HISTORIC AND DESIGN REVIEW COMMISSION

HDRC CASE NO: 2016-319
ADDRESS: 1300 GUADALUPE ST
LEGAL DESCRIPTION: NCB 2444 BLK 1 LOT 19 AND 20
ZONING: C3 HL
CITY COUNCIL DIST.: 5
LANDMARK: Null
APPLICANT: Debra Dockery
OWNER: Guadalupe Cultural Arts Center
TYPE OF WORK: Window and door replacement
REQUEST:

GUADALUPE CULTURAL ARTS CENTER FORMER PROGRESO PHARMACY RENOVATION

A3.2

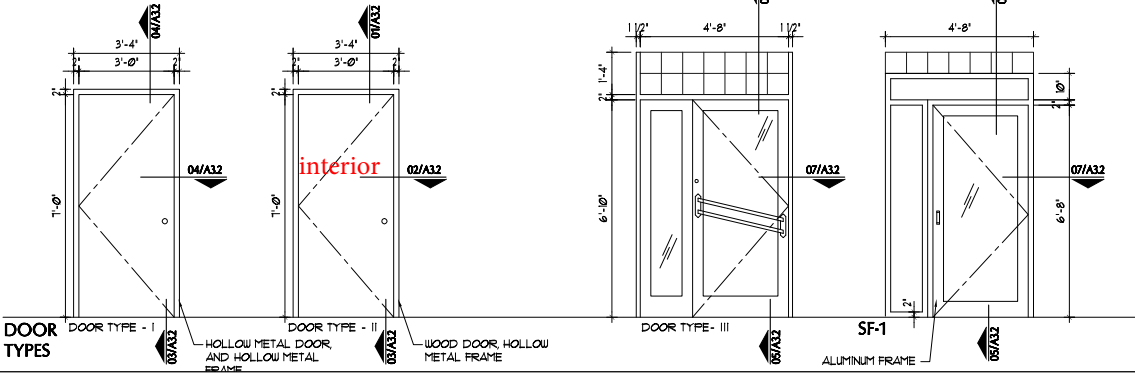
Existing Windows	Existing Condition
A: 1, 2	Aluminum, good
B: 1,2	Aluminum, replace (non-original Plexiglas)
C: 1, 2, 3	Aluminum, replace (Deteriorated beyond 50% or replaced with non-original Plexiglas)
D: 1-10	Wood, replace (All 10 deteriorated beyond 50%)
E: 1, 2	Wood, repairable
F: 1, 2	Wood, repairable
G: 1	Wood, repairable
H: 1, 2, 3	Wood, repairable
J: 1 - 4	Wood, replace (poor condition, in rear)
K: 1, 2	Wood, replace (poor condition, in rear)
*Applicant is proposing to replace all windows in-kind

Existing Doors	Existing Condition	Proposed
100	Metal security door – OK to replace	SF-1
101	Interior – n/a	n/a
102A	Door missing – OK to replace	I
102B	Door missing – OK to replace	I
103	Aluminum double doors (Applicant says door is undersized for emergency egress)	III – Aluminum Frame, side light
104	Interior – n/a	n/a
105	Non-original wood door – OK to replace	I – Hollow metal door and hollow metal frame
106	Door missing – OK to replace	I

1. That the applicant provide a replacement plan indicating how many tiles and blocks are to be retained versus replaced.
2. That the front wood windows denoted E, F, G and H be retained and repaired.
3. That the two historic square aluminum windows be retained and repaired if needed.
4. If the applicant is considering the rehabilitation of the primary historic structure, staff recommends the applicant apply for Historic Tax Certification.

EXTERIOR ELEVATIONS

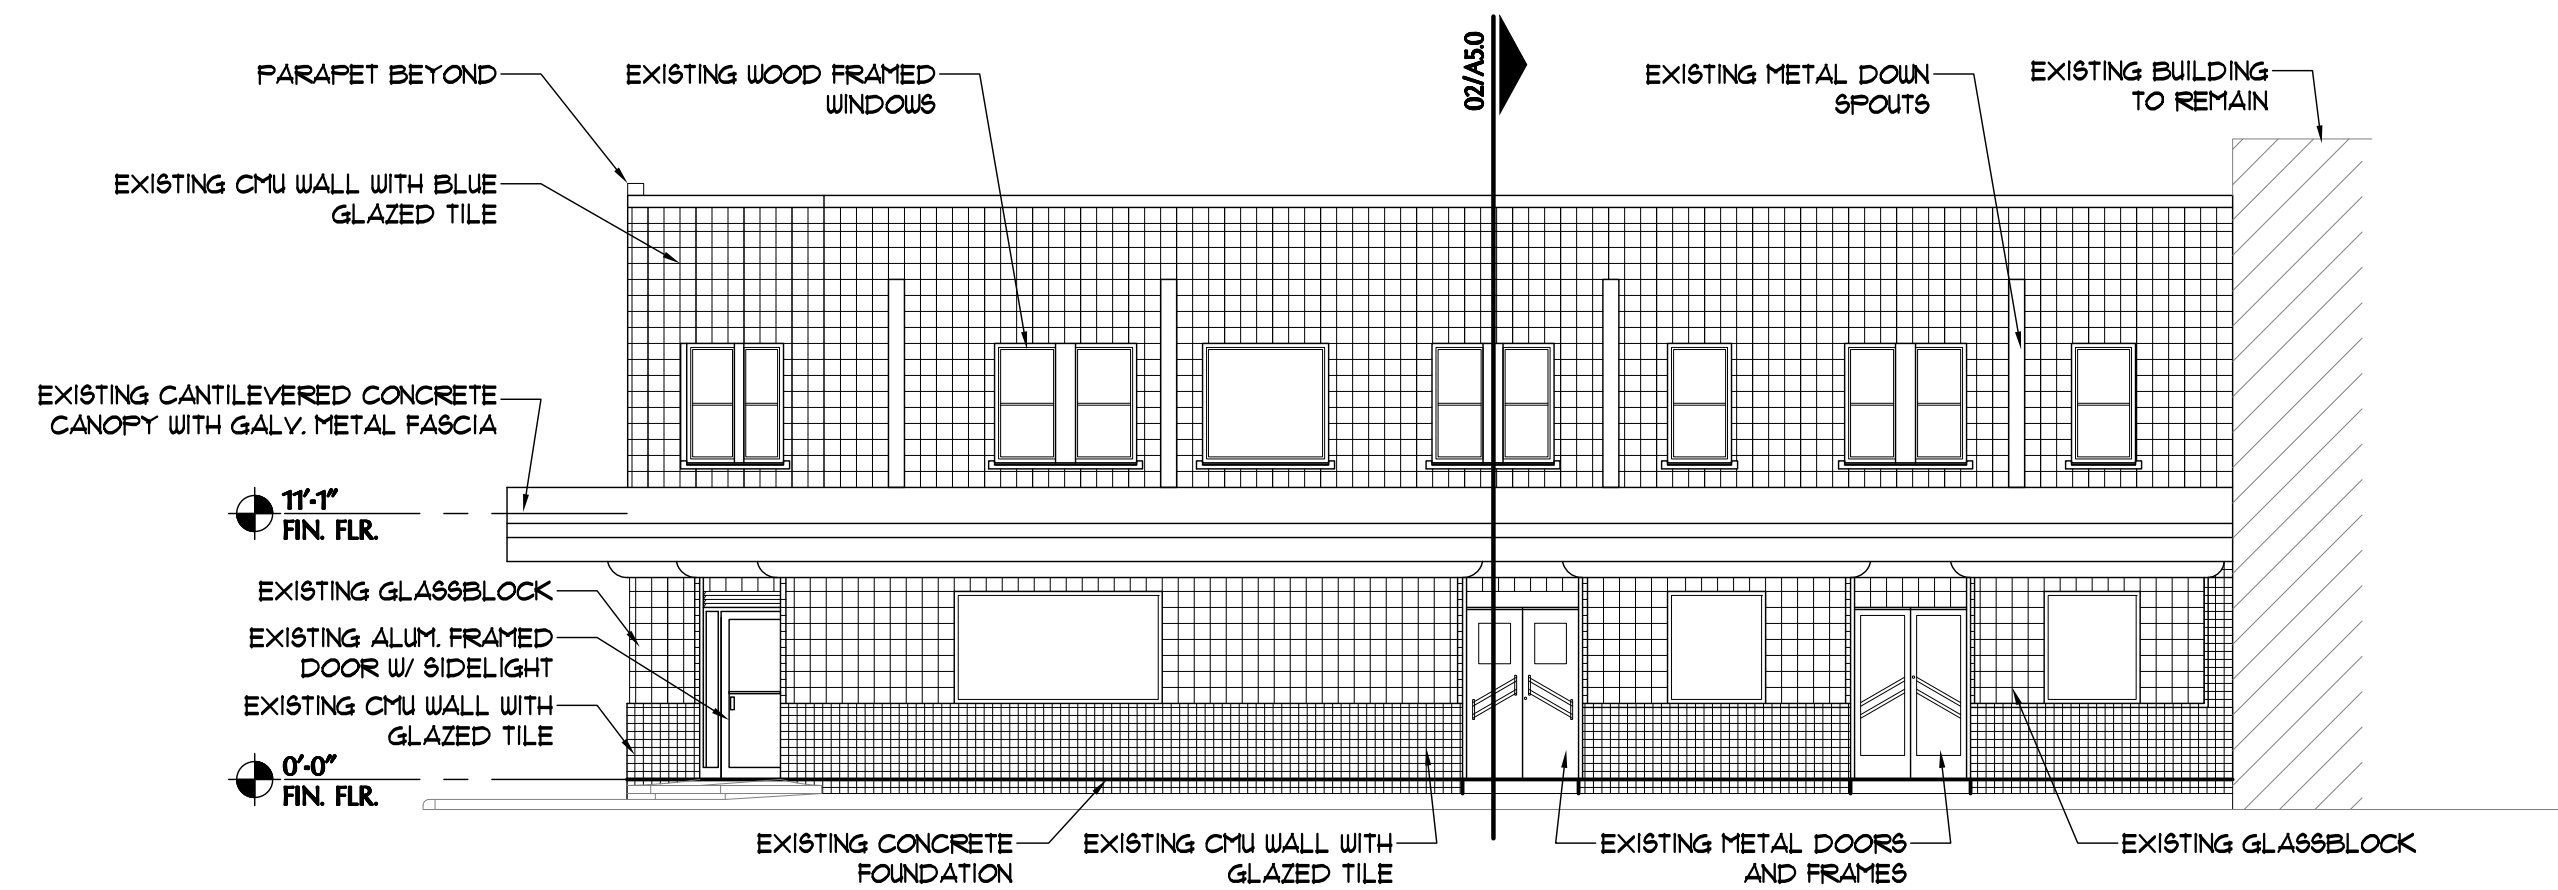
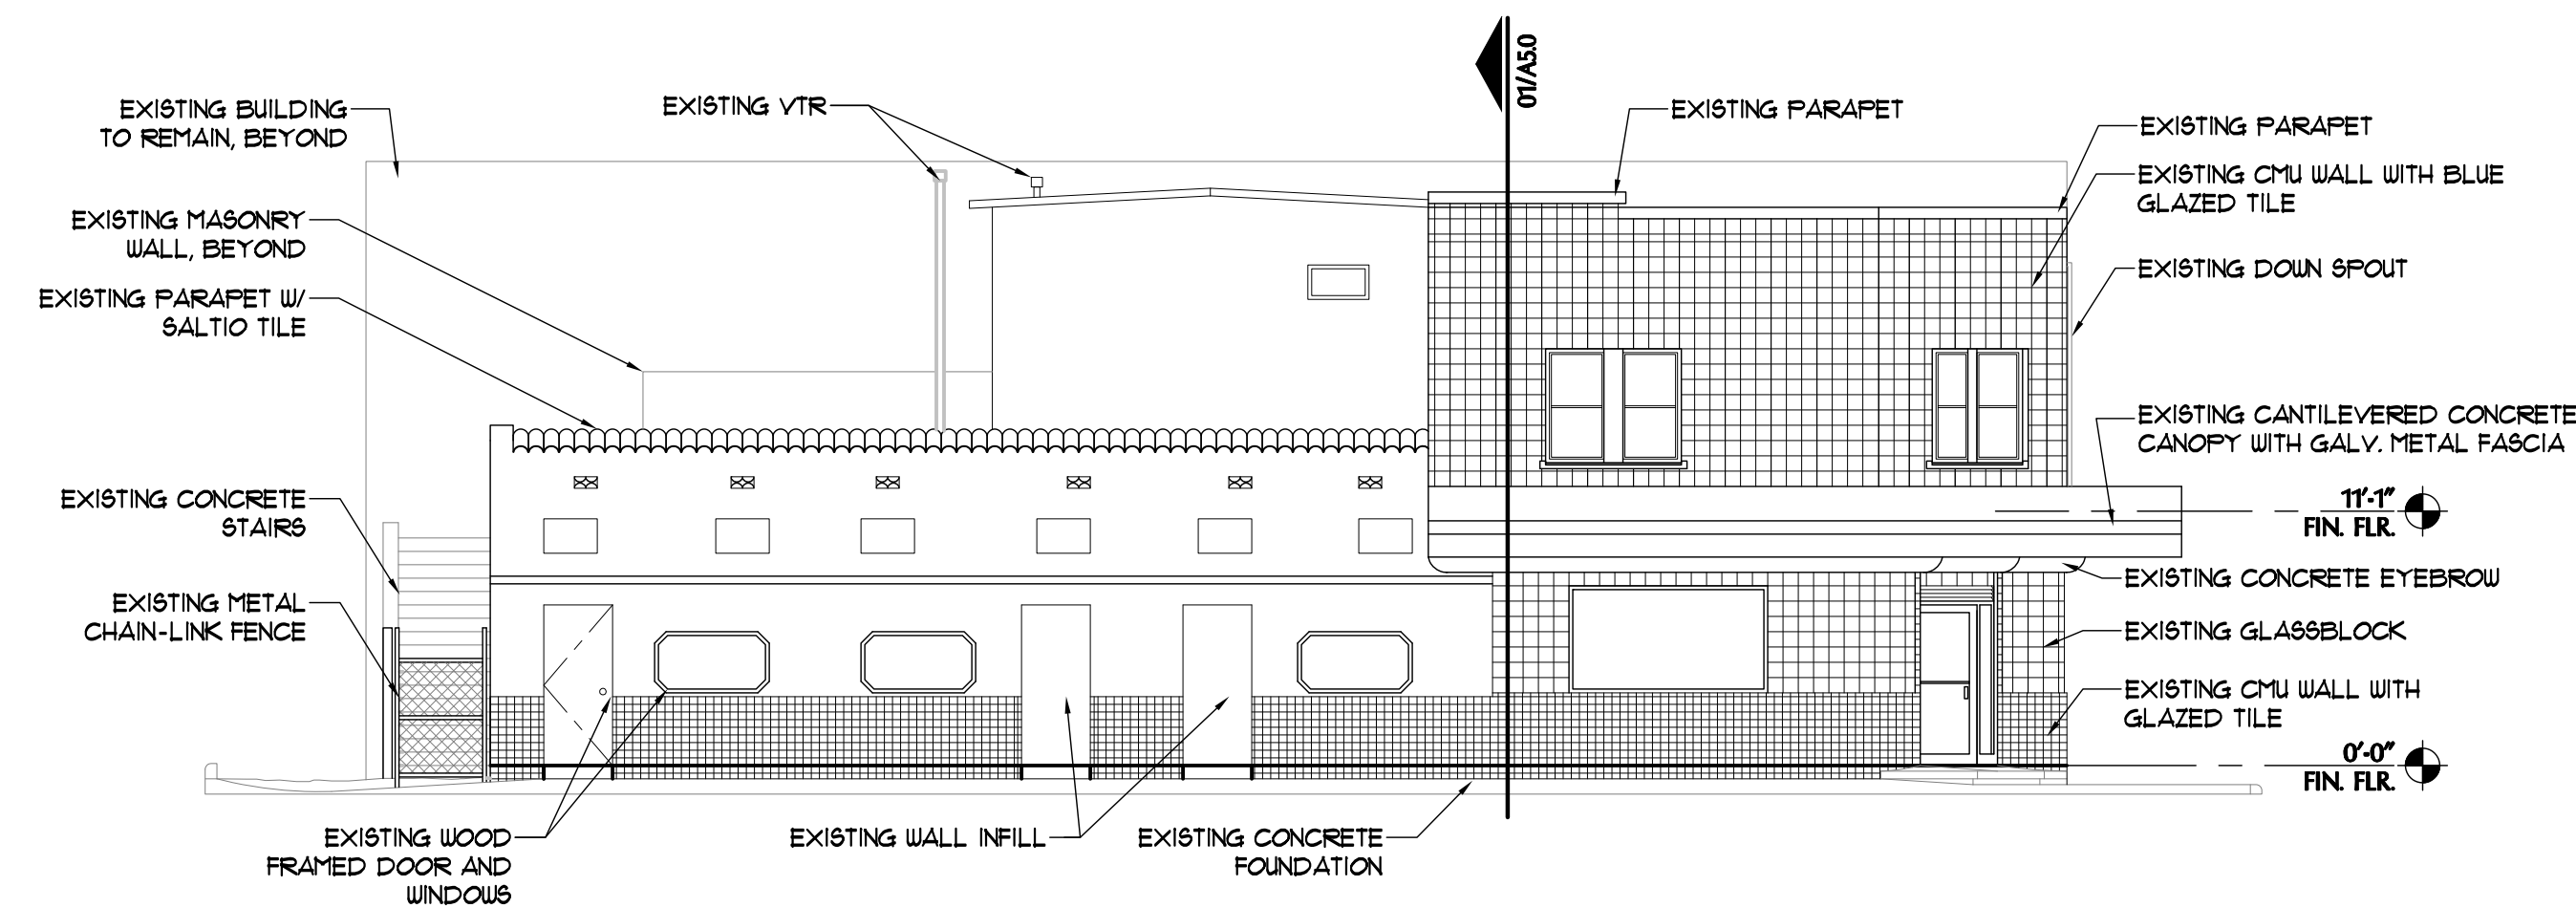
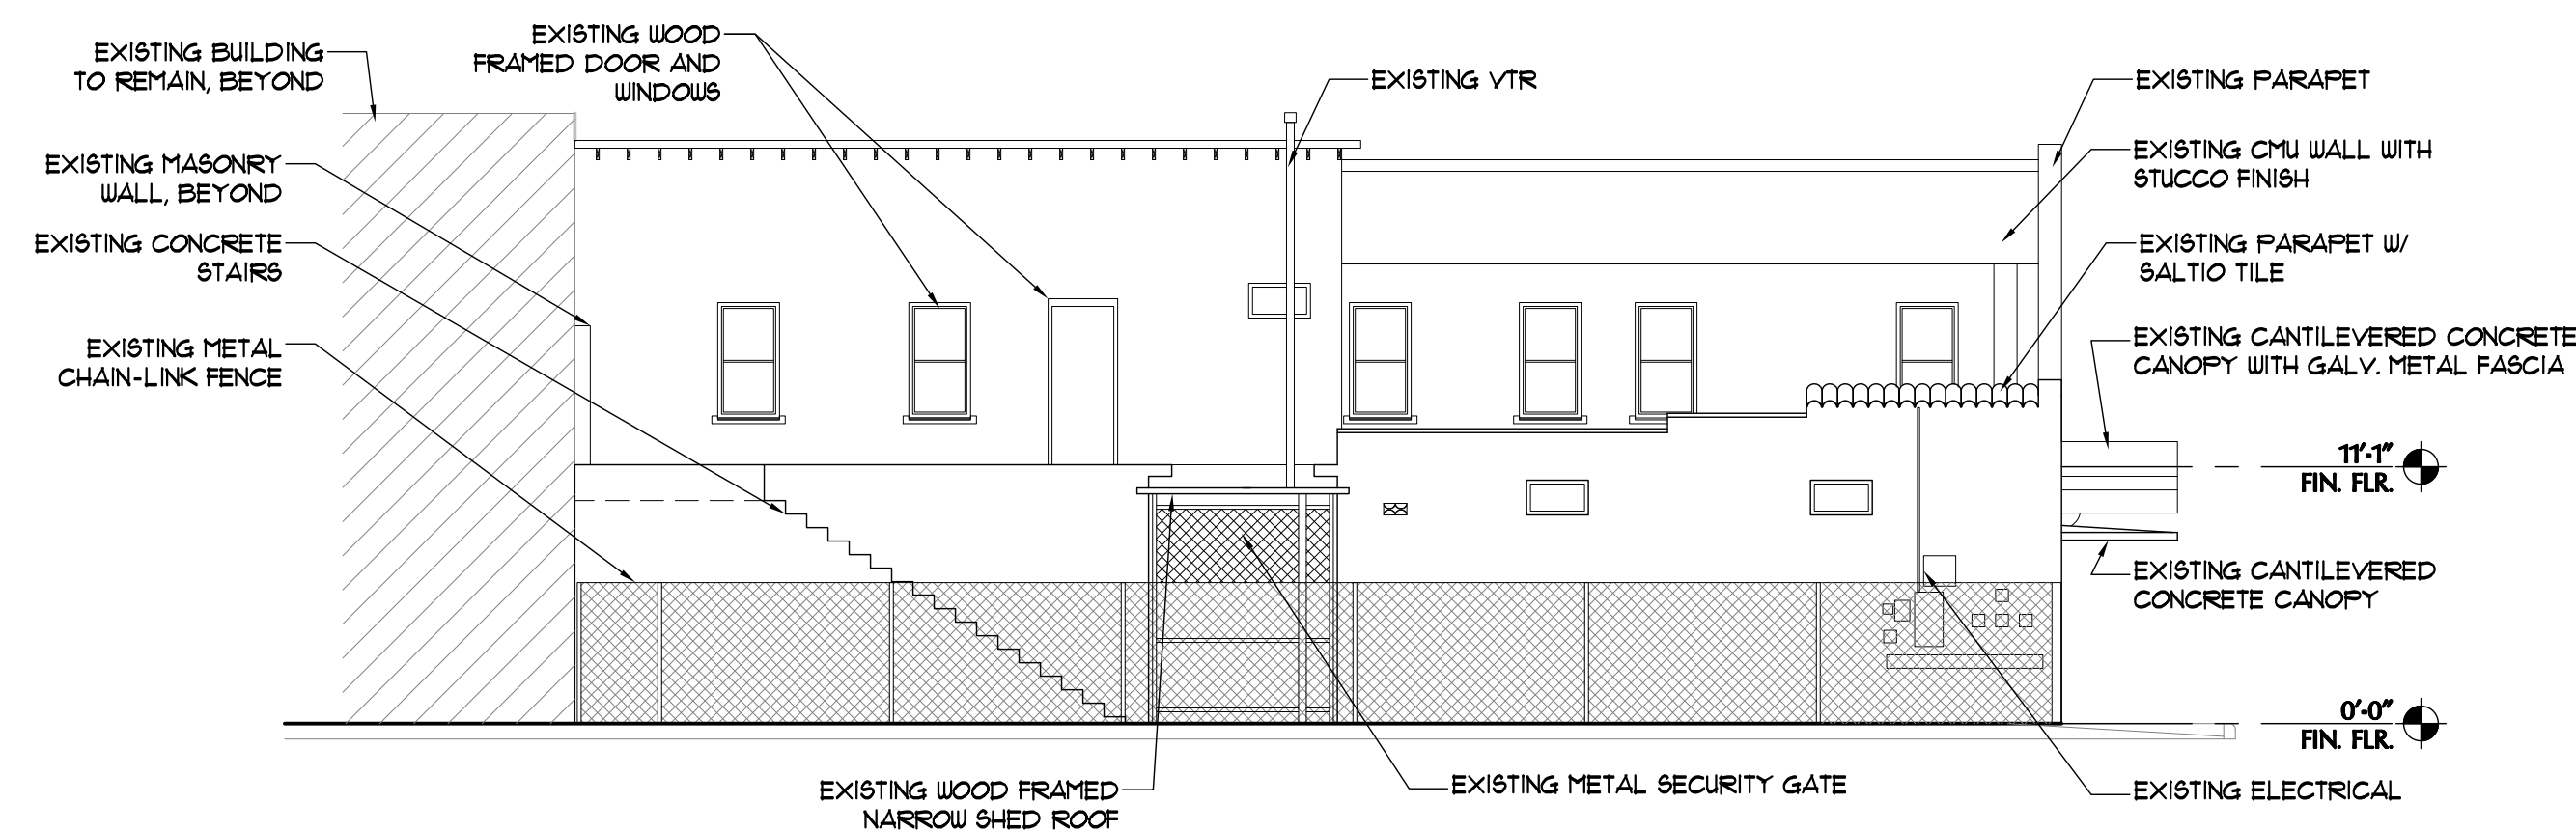
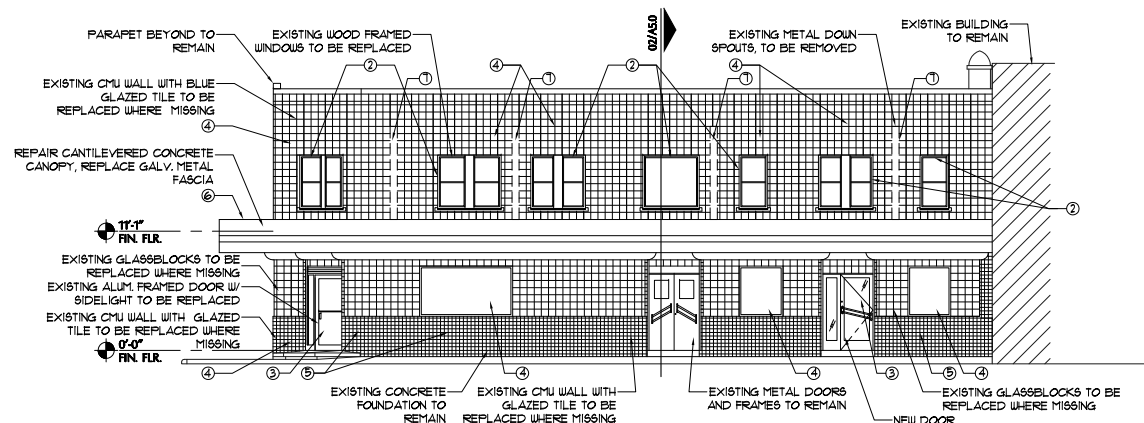
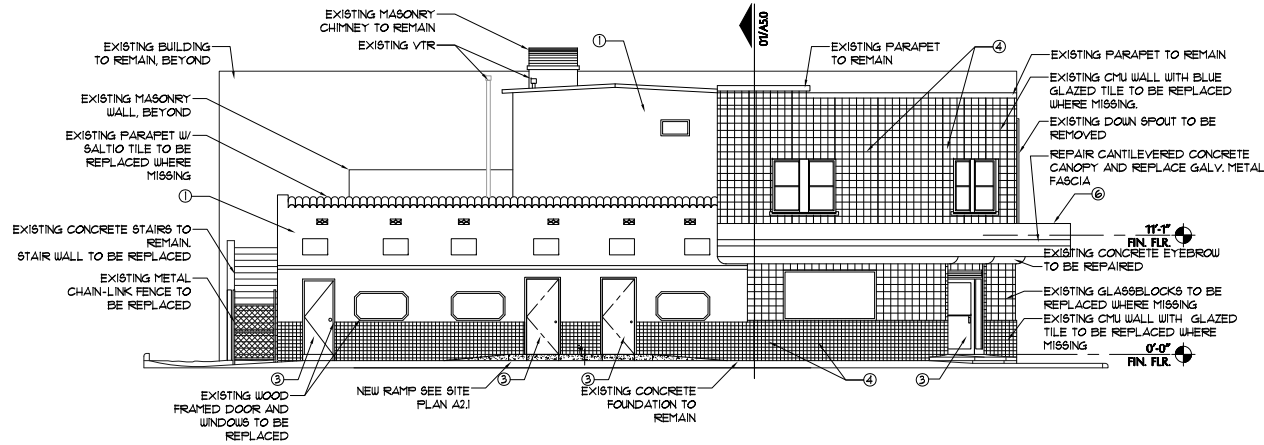
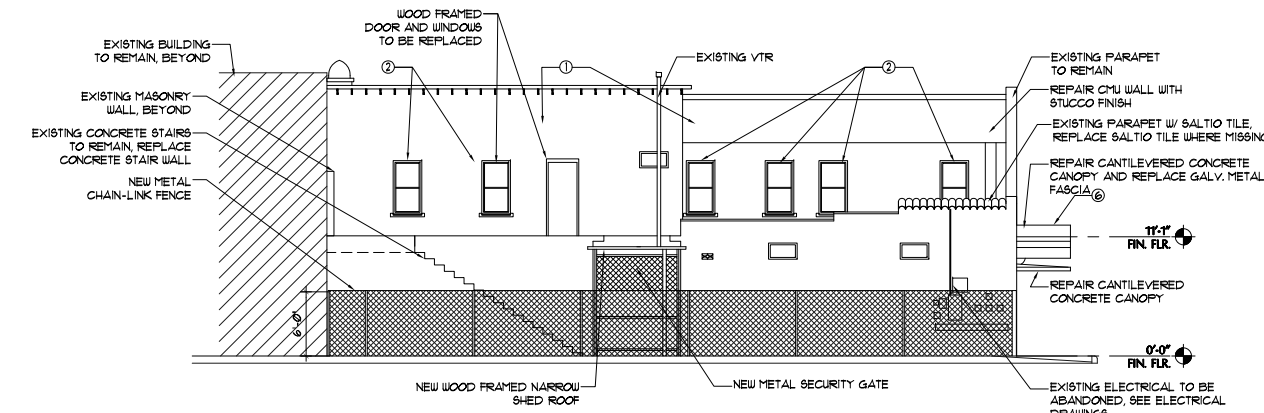
- b. On the east elevation there are two doors with one step each and masonry pavers on the sidewalk. The applicant is proposing to install a concrete ramp and landing. The existing masonry pavers will be removed under the new concrete ramp. There are no railings proposed. According to the Guidelines for Site Elements 8., ramps should be installed that do not damage historic character of the building, incorporate minor grade changes, use complimentary materials, and use a secondary entrance. The proposal is not to the primary entrance, and in minimal is elevation. Staff finds the proposal consistent with the Guidelines.

- c. There are 24 existing wood windows of various configurations and in various states of repair. The applicant is proposing to remove all 24 windows and replace in-kind. According to the Guidelines for Exterior Maintenance and Alterations 6.B.vii., historic windows should be repaired or, if beyond 50% deteriorated, should be replaced with a window to match the original in terms of size, type, configuration, material and details, feature clear glass, and recessed within the window frame. Windows with a nailing strip are not recommended. The corresponding pages from the adopted windows policy document have been added to the exhibits for this request. Staff made a site visit August 10, 2016, and found some of the windows in the front are in need of repair but are repairable and some windows missing or deteriorated beyond 50%. Staff finds the proposal to replace all 24 wood windows not consistent with the Guidelines. Windows are an important character defining feature, therefore, staff recommends that they are retained and repaired.

- d. The applicant is proposing to replace 6 existing wood windows on the rear façade of the structure. The applicant noted that the proposed replacement windows will match the original windows in profile, material and detailing. Staff finds that the replacement of the existing windows in kind is appropriate given that the rear façade lacks architectural detailing and is not seen from the public right of way.

- e. There are 7 aluminum windows on the first floor. There are two large square aluminum windows on the first floor on the north elevation, 3 hexagonal windows on the east elevation, and two large picture windows. The applicant is proposing to replace all 7 anodized aluminum double pane insulated windows to look match the historic look and profile. According to the Guidelines for Exterior Maintenance and Alterations 6.B.vii., historic windows should be repaired or, if beyond 50% deteriorated, should be replaced with a window to match the original in terms of size, type, configuration, material and details, feature clear glass, and recessed within the window frame. Staff made a site visit on August 10, 2016, and found that five of the two are deteriorated beyond 50% or are non-original Plexiglass. The two large square windows on the north elevation appear in good condition. Staff finds the proposal to replace 5 of the 7 consistent with the Guidelines, but recommends that the two historic aluminum windows be retained and repaired if needed.

- f. There are 7 exterior doors, two of which are character defining doors, and the others are non-original or have been in-filled. The applicant is proposing to replace 6 of the 7 exterior doors. The applicant is proposing to install hollow metal doors in secondary door openings and replace the corner door and the right double doors on the

north elevation with an aluminum frame door, with window lights and a transom light. According to the Guidelines for Exterior Maintenance and Alterations 6.B.i., replace doors when deteriorated beyond repair and when in-kind replacement is not feasible, ensure the features match the size, material and profile of the historic element. The proposed door for the double doors is not in-kind, but staff finds is appropriate solution to the problem of enlarging the emergency egress. Staff finds the proposal replacements appropriate and consistent with the Guidelines.

ALL WINDOWS ON THE SECOND FLOOR NORTH ELEVATION ARE CONSTRUCTED OF WOOD. ALL OF THE WINDOWS HAVE WOOD ROT, AND ARE LEAKING WATER WHEN IT RAINS. THE GLASS DOES NOT MEET THE ENERGY CODE FOR AN AIR CONDITIONED SPACE. IT IS PROPOSED TO REPLACE THE WINDOWS WITH WOOD TO MATCH THE EXISTING/ HISTORIC PROFILE CONDITION.

ALL WINDOWS ON THE FIRST FLOOR NORTH ELEVATION ARE ALUMINUM. SEVERAL OF THESE WINDOWS HAVE BEEN REPLAED WITH PLEXIGLAS. THE GLASS OR PLEXIGLASS DOES NOT MEET THE ENERGY CODE FOR AN AIR CONDITIONED SPACE.IT IS PROPOSED TO REPLACE THE WINDOWS WITH ALUMINUM AND GLASS TO MATCH THE EXISTING/ HISTORIC PROFILE CONDITION.

DOOR 103 IS AN ALUMINUM AND GLASS DOOR. THIS DOOR HAS A 2'-4" CLEAR OPENING AND DOES NOT MEET EMERGENCY EGRESS OR ADA. IT IS PROPOSED TO REPLACE THE DOOR WITH A SINGLE 3'-0" WIDE DOOR AND SIDELIGHT, BUT IN SAME MATERIAL AND DOOR CONFIGURATION AS EXISTING.

NORTH ELEVATION - WINDOWS & DOORS
SEE SHEET A3.1 FOR WINDOW SCHEDULE

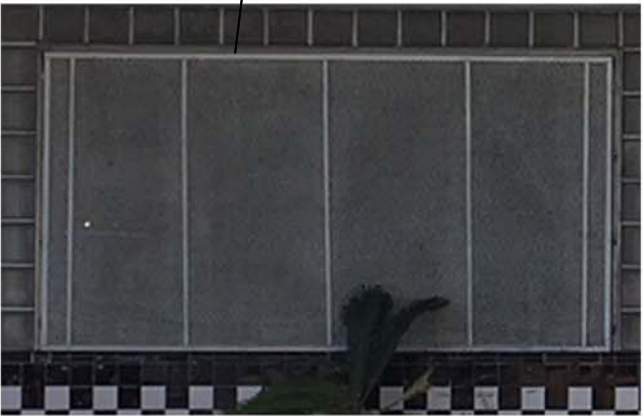
103 - DOOR IS UNDERSIZED FOR EMERGENCY EGRESS

B - WINDOW HAS BEEN REPLACED WITH PLEXIGLAS
